## SERVICE BULLETIN 19-10-10 REV 1

**Subject:** Fuel System double banjo bolt

**Affected Models:** RV-12iS using a Rotax 912iS Sport Engine

**Figure 1: Banjo Bolt Head Details**

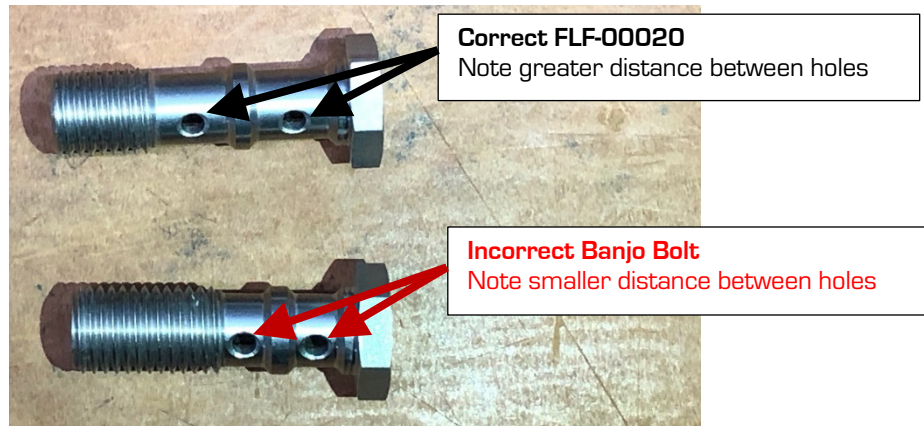
Step 2: Visually inspect the head of the FLF-00020 Double Banjo Bolt to see if the correct hardware is installed. See Figures 1 and 2.

- If the correct hardware is installed, proceed to Step 5.
- If the incorrect hardware is installed, proceed to the next step.

Step 3: Remove incorrect FLF-00020 Double Banjo Bolt and the three FLF-00024 Crush Washers. See the RV-12iS Maintenance Manual Section 13 and KAI Section 27iS/U.

Step 4: Install the new FLF-00020 Double Banjo Bolt and three FLF-00024 Crush Washers. See the RV-12iS Maintenance Manual Section 13 and KAI Section 27iS/U.
